22 June 2012

**RENOVATIONS & ADDITIONS  
NORTHWEST HIGH SCHOOL  
CLARKSVILLE, TN**

**ADDENDUM NO. TWO**

**FP110**

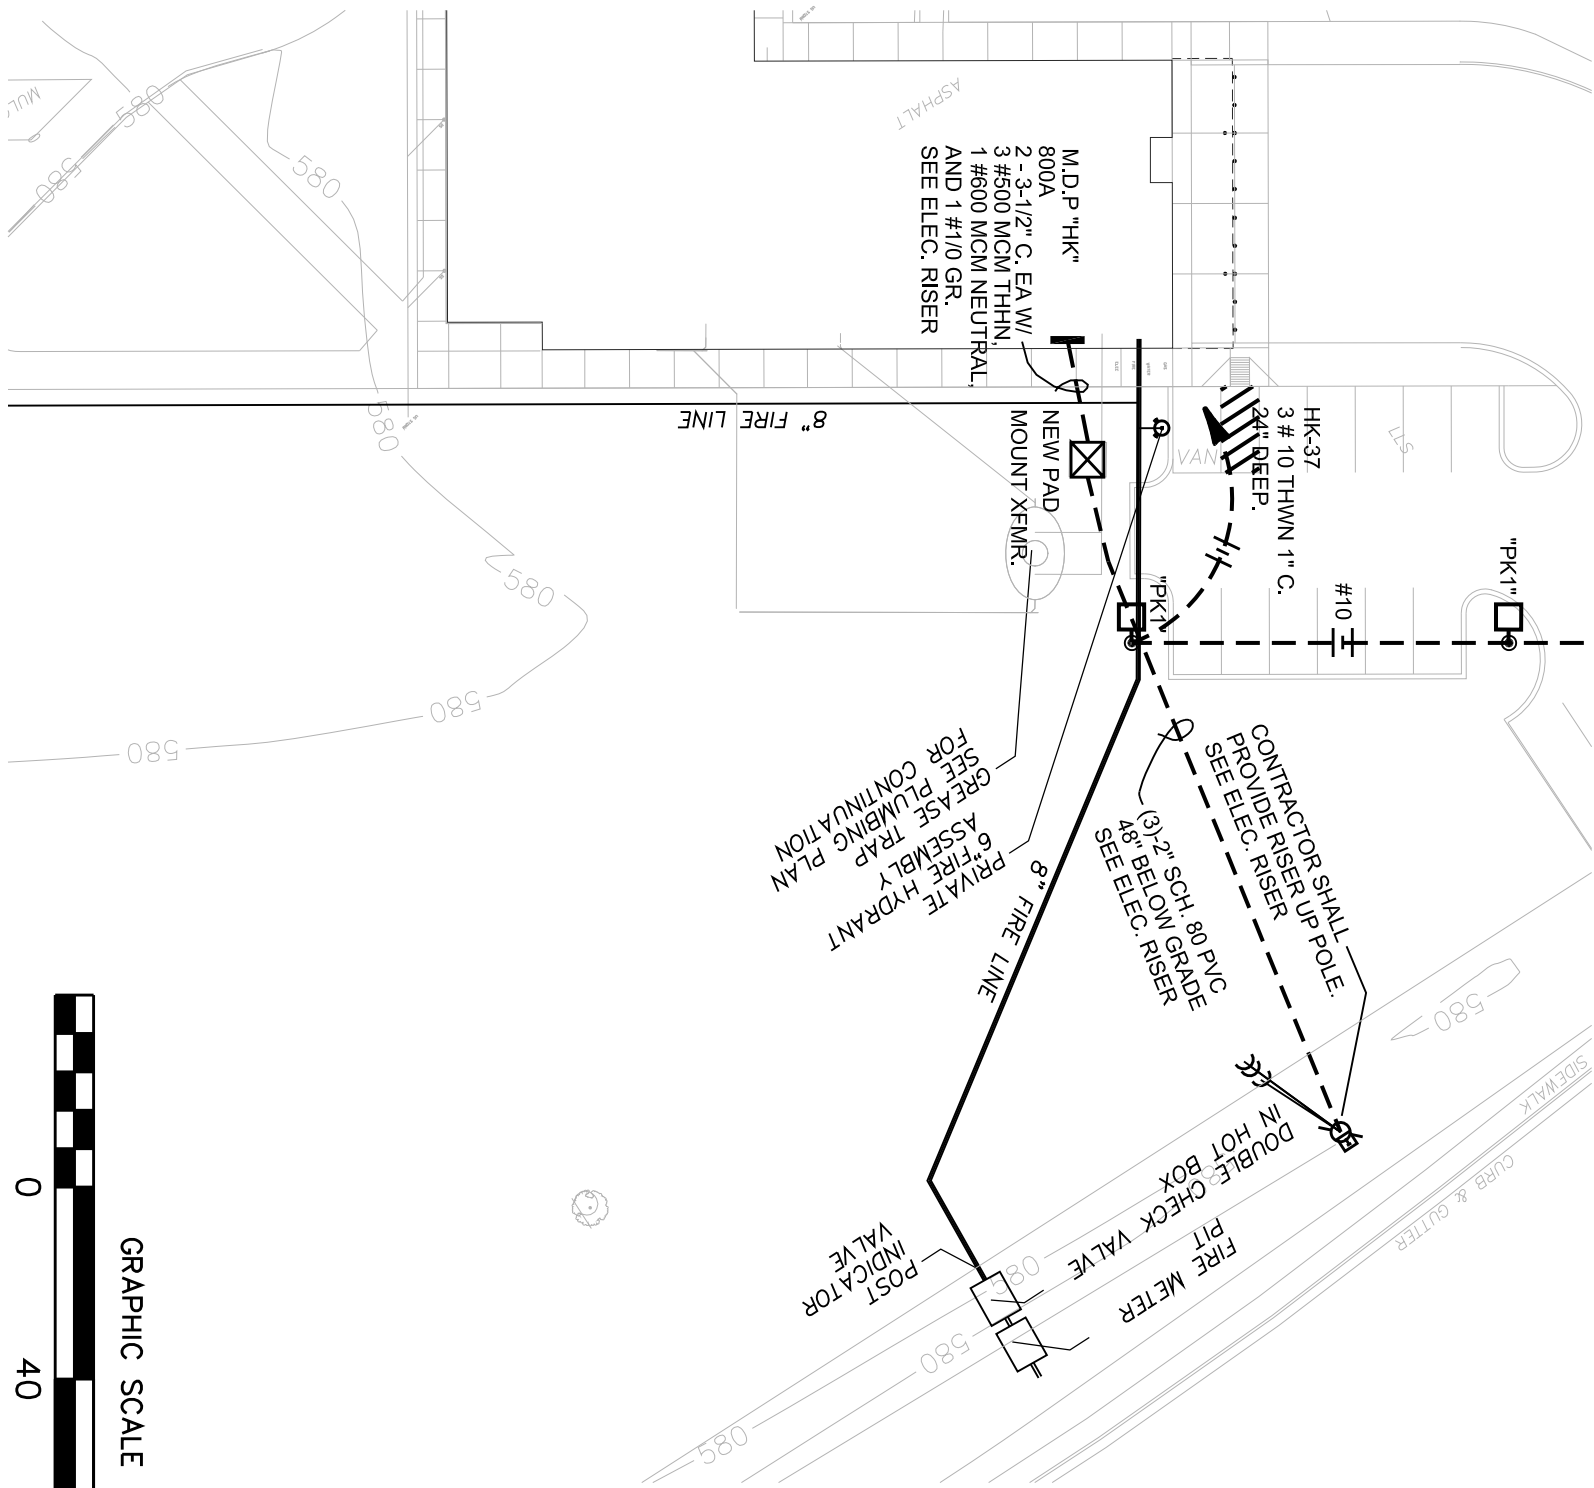
1. Refer to Sheet FP110 – Refer to A110 Note 16. This note applies to all trades and is the only location to pass through between 080 – Corridor and 081 – Serving. Refer to FP110 Addendum #2 – Attachment #1 for revised drawing.
